NUCLEAR REGULATORY COMMISSION STAFF  
SAFETY EVALUATION  
OF  
U. S. DEPARTMENT OF ENERGY  
QUALITY ASSURANCE PROGRAM DESCRIPTION  
FOR THE  
OFFICE OF CIVILIAN RADIOACTIVE  
WASTE MANAGEMENT

MAY, 1989

FIGURE 1  
OFFICE OF CIVILIAN RADIOACTIVE WASTE MANAGEMENT  
ORGANIZATION

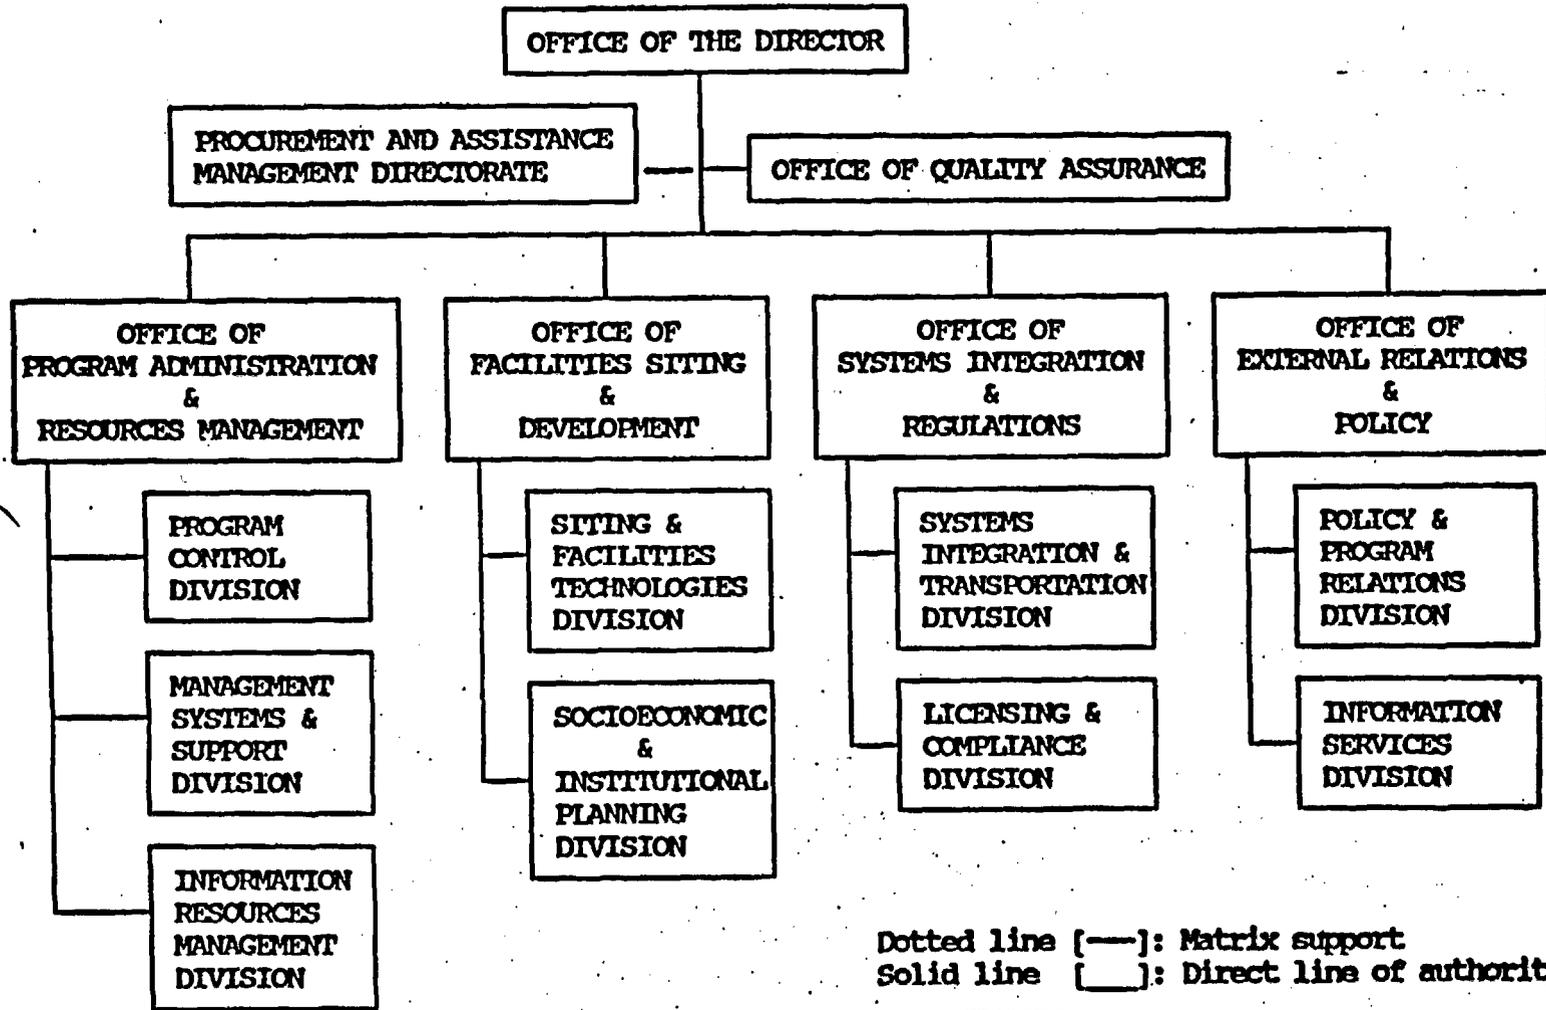
The NRC staff recommends that DOE incorporate the above guidance into the QAPD to better define the responsibilities of the QA and and line organizations. This is identified as an open item in Section 5 of this evaluation. With the inclusion of the above into the QAPD, the QAPD meets the ANSI/ASME NQA-1-1986 (see Ref. 7) criteria for QA organization responsibilities and is acceptable to the NRC staff. However, for the implementation of the QAR and the QAPD, the NRC staff believes that DOE should continue to have the additional QA involvement currently prescribed in the YMP 88-9 QA Plan (see Ref. 1) and the QAPD, since the program has not yet been shown to be effective. When DOE wishes to have less QA involvement, it should meet with the NRC staff and discuss which QA functions will be transferred to the line organization and how the independence will be maintained to assure that the line organization is effectively performing its respective QA/quality control functions and is in compliance with the requirements for organizational responsibilities, including paragraph 2 of NQA-1 (see above).

In Section 3.1 of this SE, a discussion is provided pertaining to guidance on the role of the QA organization. DOE should incorporate the guidance from paragraph 2 of ANSI/ASME NQA-1-1986 Nonmandatory Appendix 1A-1 into the next revision of the QAPD.
